Access Compliance Report

Public Rights-of-Way

Intersection ID: 54158	Main Street: SANDERS_FARM_LN	Cross Street: SKIDMORE_LN	Location: NW
ADA ID: 2E37A8530CE0	Ramp Type: PerpDiag	Initial Pass/Fail: Fail	Overall Compliance: No
Severity Score: 13.75			
Codes/Mitigation Info/Possible Solution		Field Measurements/Component Compliance

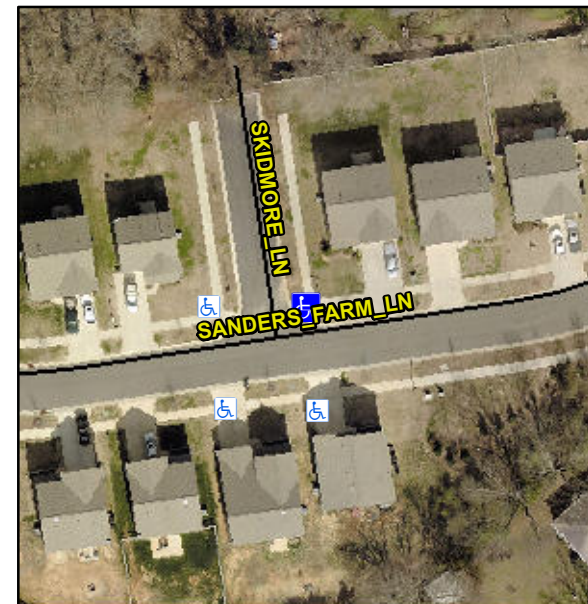
Not Found, R304.2.2, R304.5.3

Compliance	Description	Data	Compliance	Description	Data
N/A	Ramp Length (in)	95.0	No	Ramp Slope (%)	9.2
Yes	Ramp Width (in)	59.5	No	Ramp XSlope (%)	2.9
N/A	Flare Type LT	N/A	N/A	Flare Type RT	N/A
N/A	Flare Slope LT (%)	N/A	N/A	Flare Slope RT (%)	N/A
N/A	Flare Traversable LT?	N/A	N/A	Flare Traversable RT?	N/A
N/A	Landing Length (in)	N/A	N/A	DWS Provided?	N/A
N/A	Landing Width (in)	N/A	N/A	DWS Contrast?	N/A
N/A	Landing Slope (%)	N/A	N/A	DWS Length (in)	N/A
N/A	Landing X Slope (%)	N/A	N/A	DWS Full Width?	N/A
N/A	Landing Curb? (Y/N)	N/A	N/A	DWS Offset (in)	N/A
N/A	Shared Landing?	N/A			
N/A	Gutter Ponding?	N/A	N/A	Gutter Slope (%)	N/A
N/A	Gutter Lip Ht (in)	1.5	N/A	Gutter X Slope (%)	N/A
N/A	Painted X Walk1?	No	N/A	Painted X Walk2?	No
	X Walk 1 Direction	To W		X Walk 2 Direction	To S
N/A	X Walk 1 Width (in)	N/A	N/A	X Walk 2 Width (in)	N/A
	X Walk 1 Slope (%)	3.0		X Walk 2 Slope (%)	4.5
	X Walk 1 X Slope (%)	2.8		X Walk 2 X Slope (%)	1.8

Remove & Replace Curb Ramp With Two New Directional Ramps or Equivalent.
